# TECHNICAL INFORMATION

No: 84/01/00/NAS  
Ref:  
Issue: 1  
Date: 04/21/00

## Wiper Mechanism Washer Corrosion

Discovery Series II (LT)

Figure 1

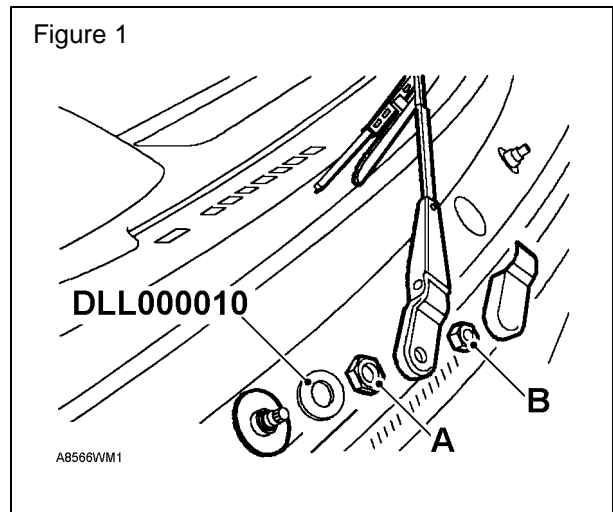
Poor finish durability may cause a customer complaint regarding deteriorating appearance of the washers behind the wiper arms on the windshield wiper mechanism.

Improved durability washers have been introduced into production as of the above VIN. These washers are now available as spare parts to be installed to resolve customer complaints.

1. Refer to Figure 1 and remove the original washers as follows:
  - Remove wiper arm nut (B) and the arm.
  - Remove wiper assembly nut (A).
  - Remove and discard the deteriorated washer.
2. Install the new washers, (DLL000010) as follows:
  - Position the new washer and install the mechanism nut (A).
  - Tighten the wiper mechanism nut (A) to **7Nm (62 lbf.in.)**.
  - Install the wiper arm and tighten the wiper arm nut (B) to **15Nm (133 lbf.in.)**.
3. Go to Step 1 and repeat procedure for the alternate side.
